NUCLEAR RESEARCH CORPORATION

SUBJECT: 10CFR21 NOTIFICATION

SUBJECT: NOTIFICATION OF POTENTIAL SAFETY-RELATED MODIFICATION IN ACCORDANCE
WITH 10CFR21

To correct this condition, perform the following actions on the Relay Driver PCB Assembly (NRC P/N: 7520-xxx, Schematic 7522-xxx):

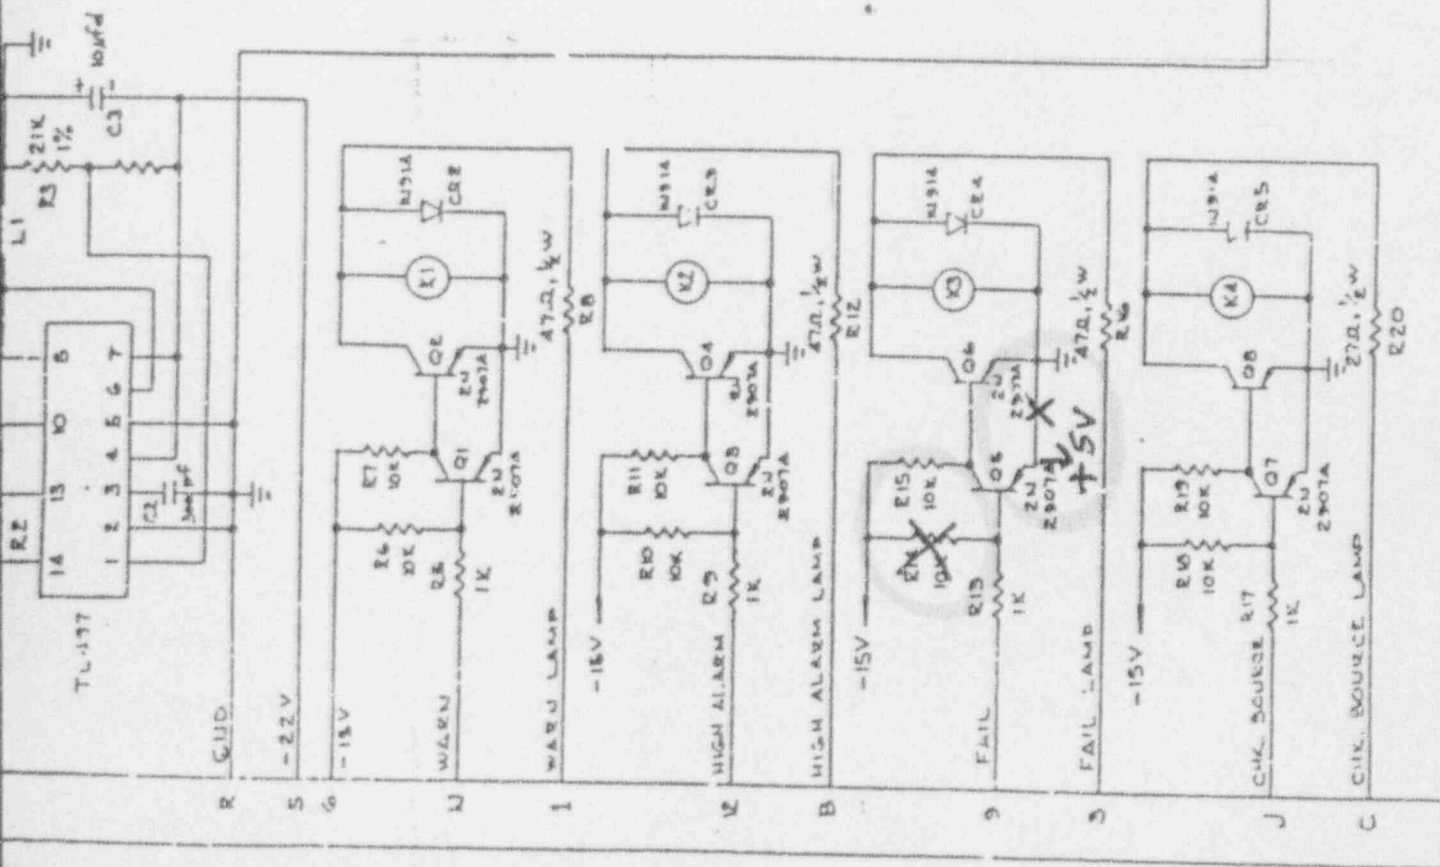
- 1) Remove resistor R14 on assembly 7520-xxx. The resistor value is 10 K ohms.
- 2) Cut the printed circuit board trace between Q6 and ground as noted on the attached modified drawings.
- 3) Add a #24-#26 AWG insulated buss wire jumper between Q6 and +5 VDC as noted on the attached modified drawings.
- 4) Return the Relay Driver PCB to the DRM-200 Ratemeter.

All references to Q6 should be corrected to reference transistor circuit designation Q5.

C-7520-001

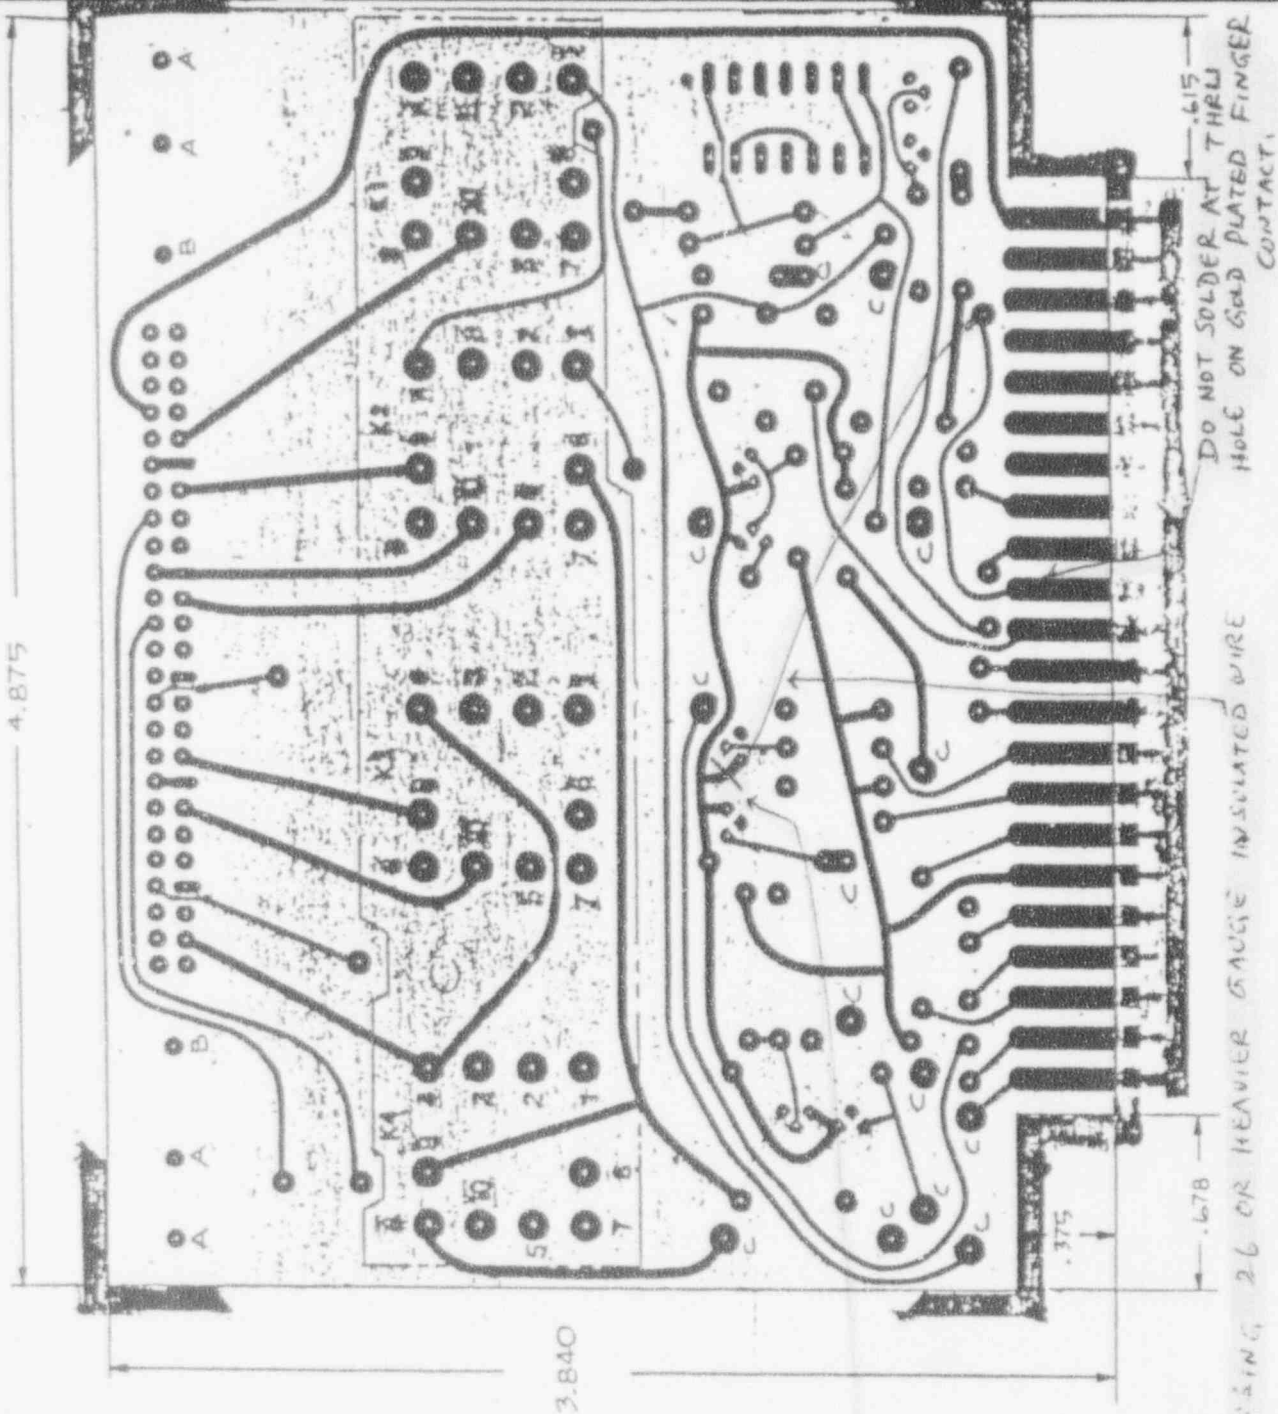
DELETE P.14

CUT THIS TRACE

CONNECT A JUMPER WIRE, 26 OR HEAVIER GAUGE INSULATED WIRE

DO NOT SOLDER AT THRU HOLE ON GOLD PLATED FINGER CONTACT
